This Addendum forms a part of the Contract Documents and modifies the original Bidding Documents dated July 2, 2026, as noted below. Acknowledge receipt of the Addendum in the space provided on the Bid Form. Failure to do so may subject the Bidder to disqualification.

4. Sheet AD101, First Floor Removals Plan, DELETE and REPLACE with attached Sheet
 - a. Clarified doorbell and card reader
5. Sheet AE101, First Floor Plan & Details, DELETE and REPLACE with attached Sheet
 - a. Clarified doorbell and card reader
6. Sheet AE501, Removal & Construction Details, DELETE and REPLACE with attached Sheet.
 - a. Clarified stair railing.
 - b. Clarified stair risers.
 - c. Clarified canopy tie backs.
 - d. Clarified height of canopy.

Project Name	Wellness Center Re-Use Renovation BGS Project #3843			
Project Number	10017003			
Date	8/3/2026			
Prepared By	Dan Rowland			
Number	Pre-Bid Request For Information	Discipline	A/E Response	Response date
1	Perimeter drain dumps where? No civil drawings	Arch	Tie into existing, if existing drains are not encountered, new perimeter drains are not required.	7/27/2026
2	Through bolts for canopy how many are needed at lower portion of canopy?	Arch	See Add

H1 FIRST FLOOR PLAN

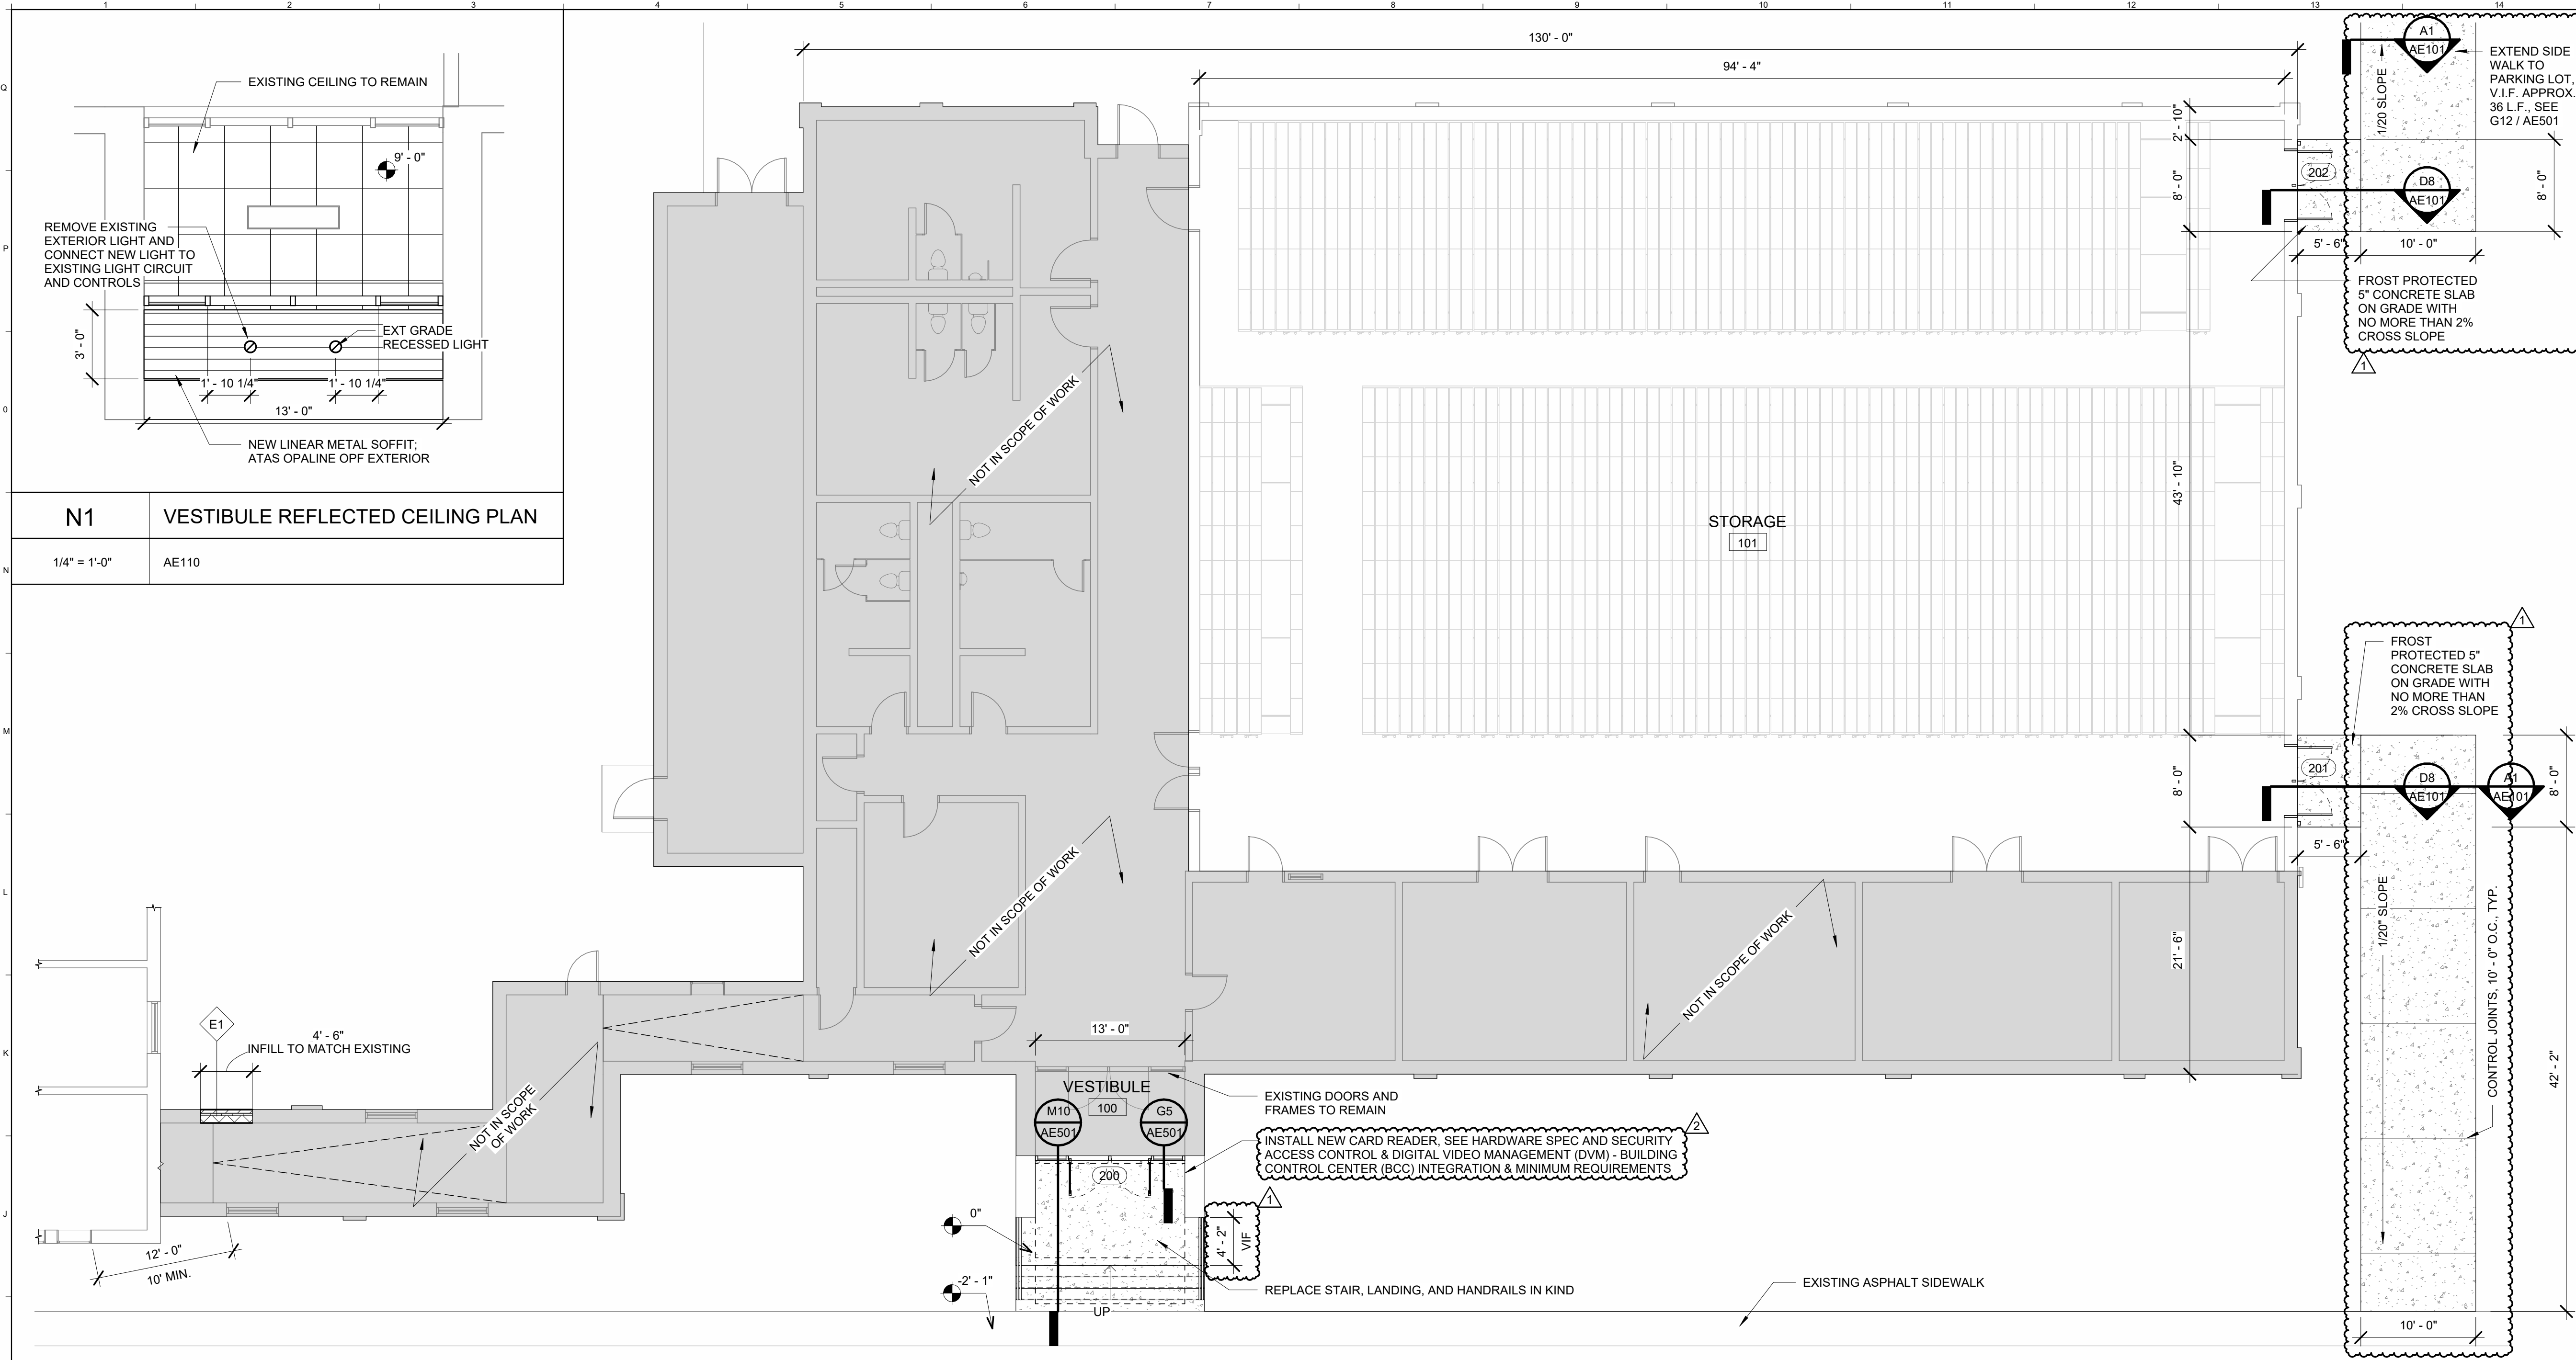
21	Sidewalk going to parking lot is just a straight path? Also is it 10'-0" to match other one?	Arch	See Addendum #01 - Sheet AE101, Plan H1 and Sheet AE501, Detail G12 are updated to reference layout of sidewalk.	7/27/2026
22	Prevailing Wage Determination (Section 00 73 46) The wage rate table referenced in Section 00 73 46 as being "shown on the following page" is missing from the issued Project Manual (page 52 contains only a stray signature graphic in place of the rate table). Please confirm whether Maine DOL/Davis-Bacon prevailing wage requirements apply to this project, and if so, please issue the missing wage rate table.	Arch	2026 Fair minimum Wage rates is included in project manual . Page 52 provides wage rates.	8/3/2026
23	Responsibility for Special Inspection Costs (Section 01 40 00, §1.7.B) Section 01 40 00, §1.7.B states that "Special Tests and Inspections" required by the Authority Having Jurisdiction are "the responsibility of Owner," while also indicating the Contractor engages with the testing agency. Please clarify whether Owner or Contractor is financially responsible for the cost of AHJ-required special inspections (including any structural inspections associated with the stair reconstruction, canopy, and foundation work).	Arch	See addendum #02 for clarification	8/3/2026

E15 TYPICAL CANOPY ELEVATION

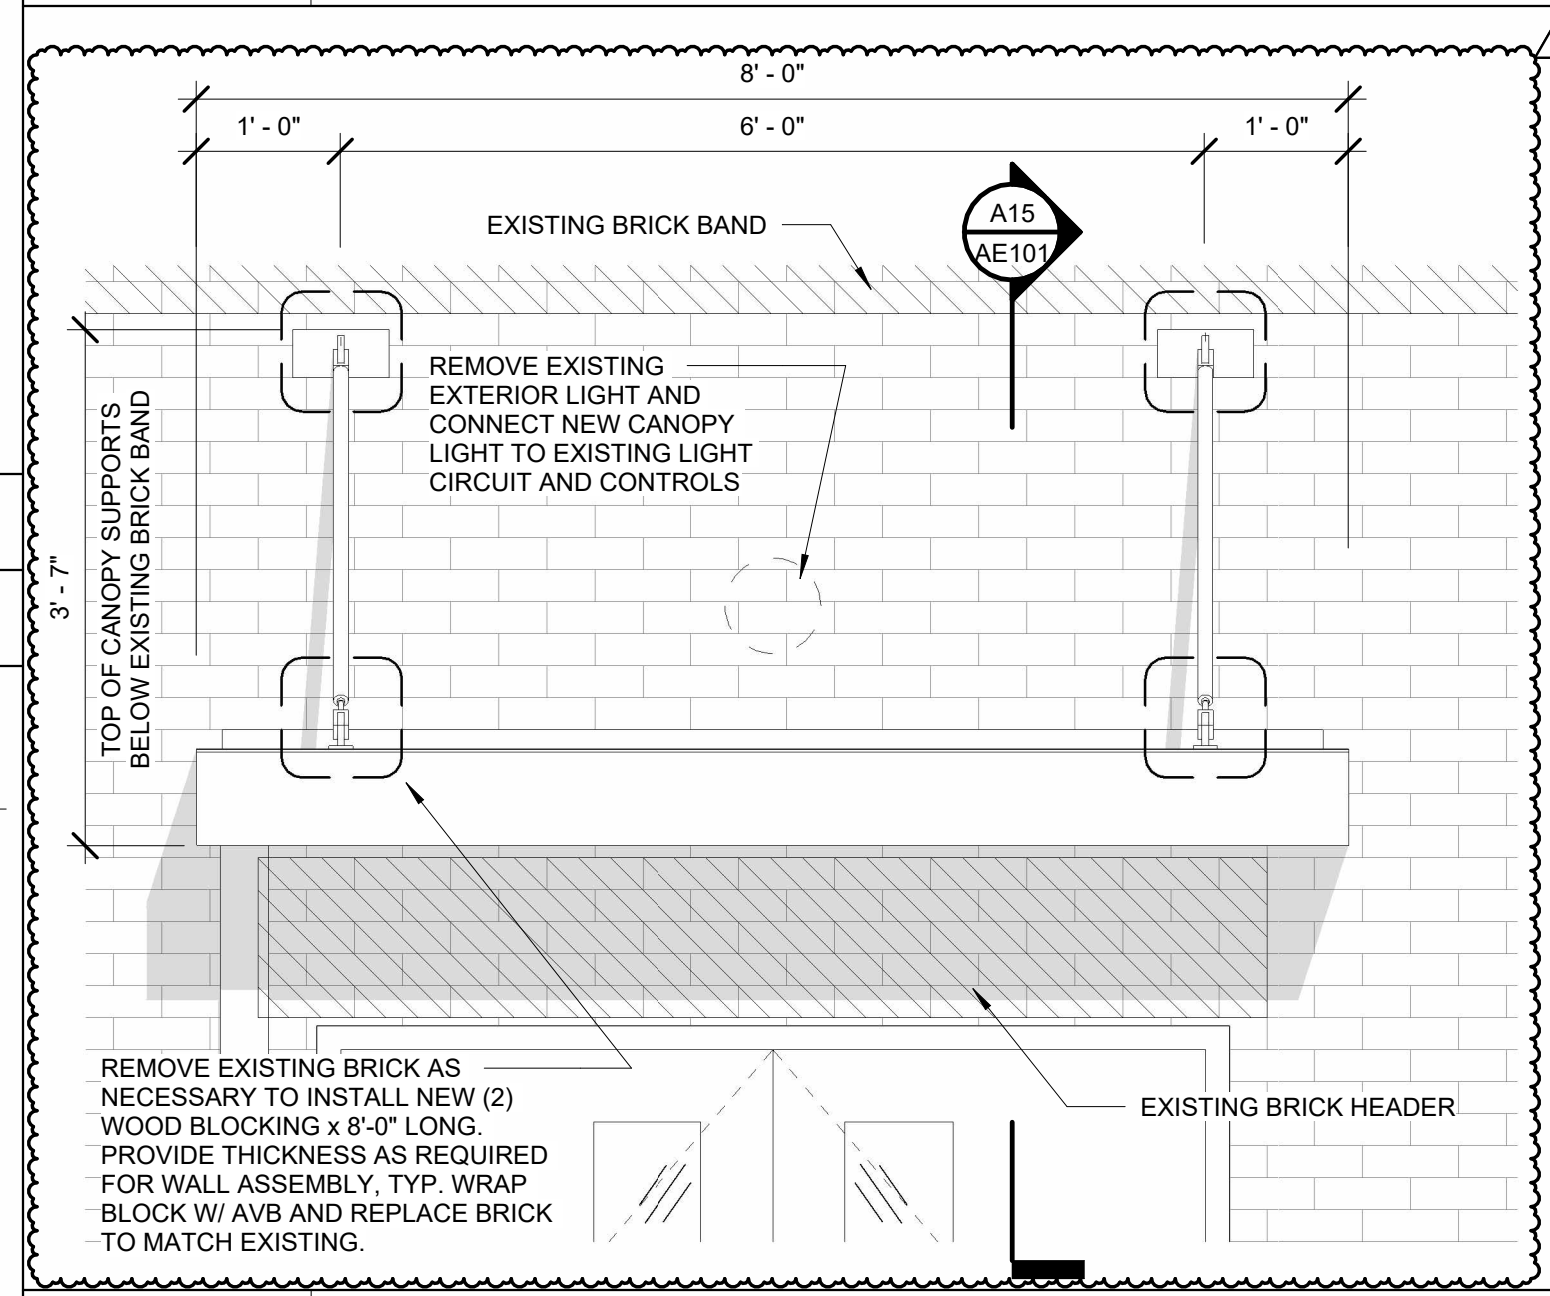
32	Doors currently have access control but there is nothing shown on the plans?	Arch	See Addendum #2 for clarification, Adds Section 087100, Door Hardware Standards – Rev. 20260528 and Security Access Control & Digital Video Management (DVM) – Building Control Center (BCC) Integration & Minimum Requirements,	8/3/2026
33	Are there any specs for this project or just what is on the plans?	Arch	Specifications for Division 00-Procurement and Contracting Requirements and Division 01 - General Requirements are included in the Project manual. Addendum #2 Adds Section 087100, Door Hardware Standards – Rev. 20260528 and Security Access Control & Digital Video Management (DVM) – Building Control Center (BCC) Integration & Minimum Requirements,	8/3/2026
34	The brick headers on the exterior doors has a brick detail that looks to be about 12" tall. The new exterior canopies will these be mounted above this?	Arch	Yes, bottom of canopy to be mounted above existing brick header at 8"-4". See sheet AE101 Detail E15 issued as part of Addendum #2	8/3/2026

A15 TYPICAL CANOPY SECTION

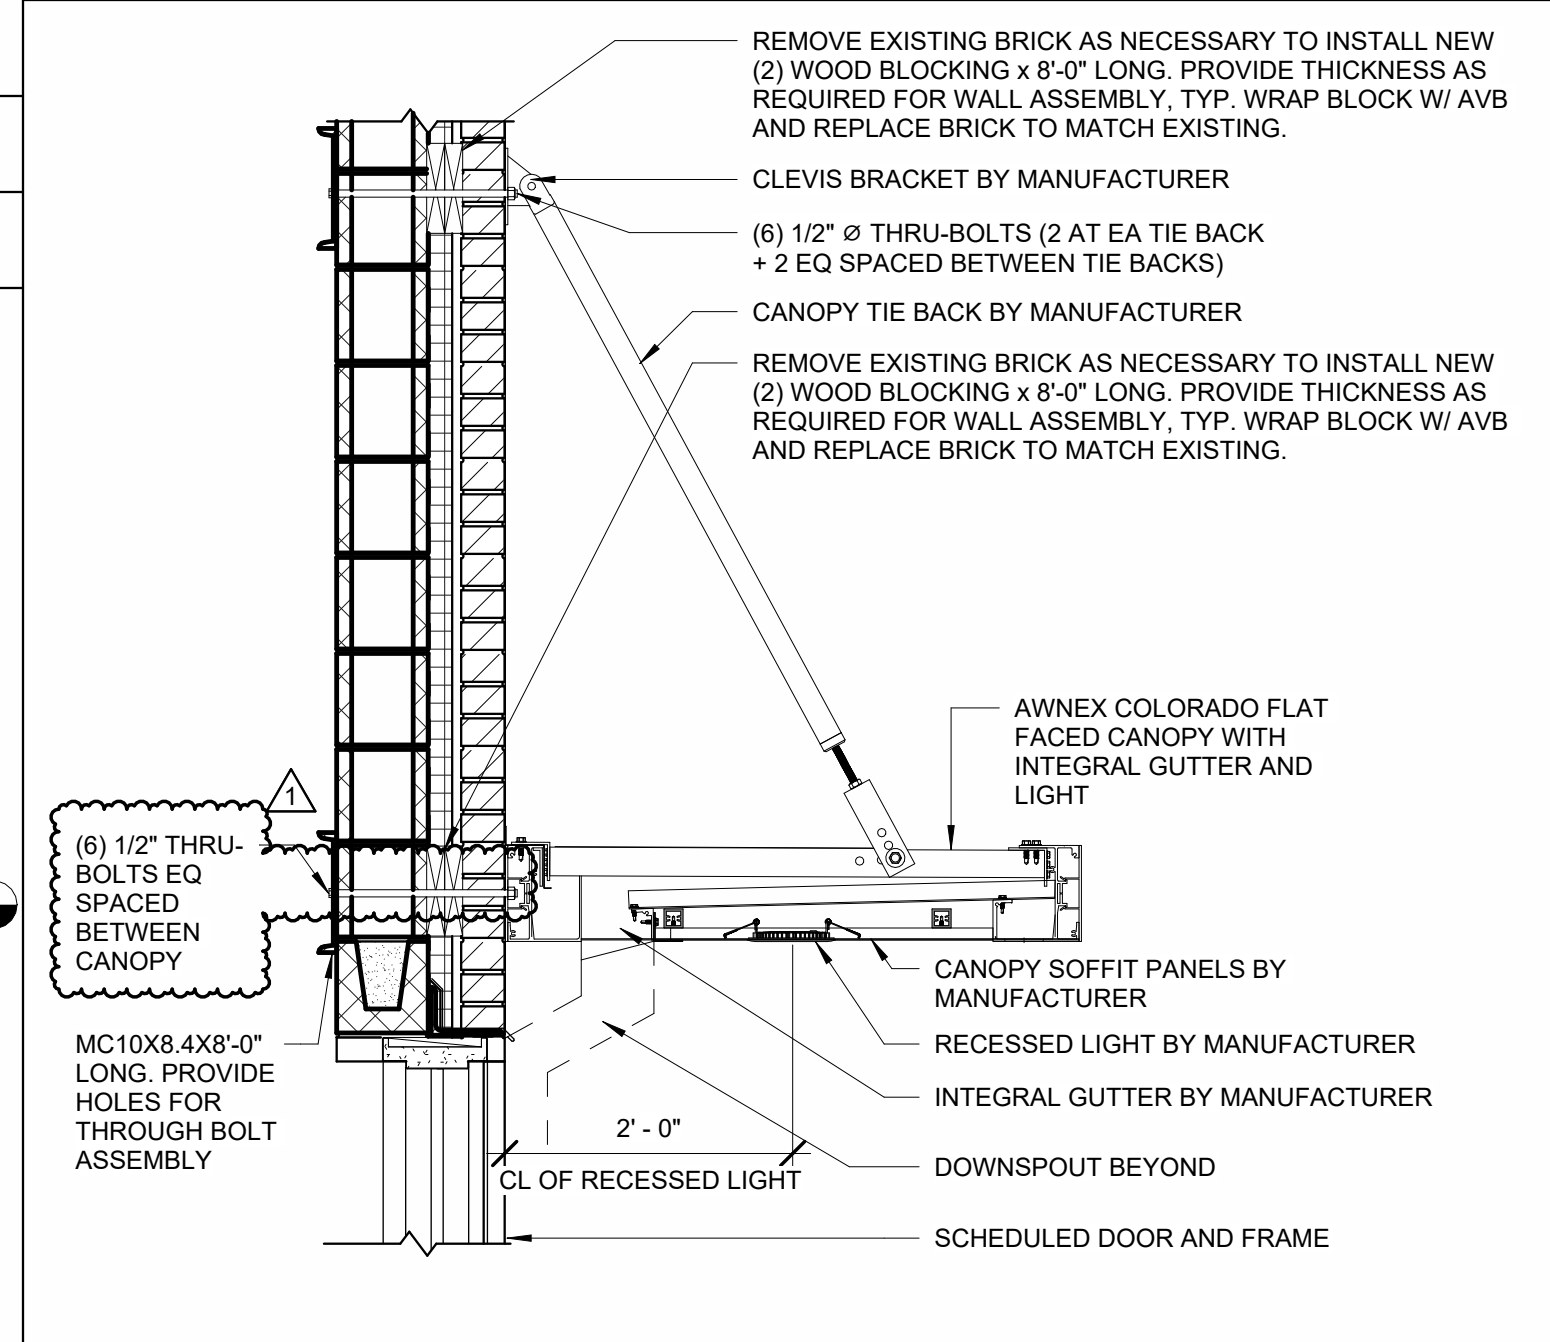
38	With the existing window being removed are we to tooth in cmu inside and remove the bullnosed cmu? Exterior brick are we to remove header detailed brick and sill and tooth in or just infill opening?	Arch	Existing bullnose head, jamb and sill to remain, infill opening. Brick header and sill to remain, infill opening.	8/3/2026
39	There is an existing tipped curbing at the parking lot where we are running the new walk way to. How are we to deal with this detail?	Arch	Flush top of sidewalk to top of curb.	8/3/2026
40	Does the foundation wall and footings for the side entry pads go on all three sides of the pad or just the long side?	Arch	Foundation wall and footings are on all three sides of the pad.	8/3/2026
41	Also it doesn't show any foundation along the sides of the stairs and how this detail or repair is supposed to be done?	Arch	Similar to A15/AE501	8/3/2026
42				
43				
44				
45
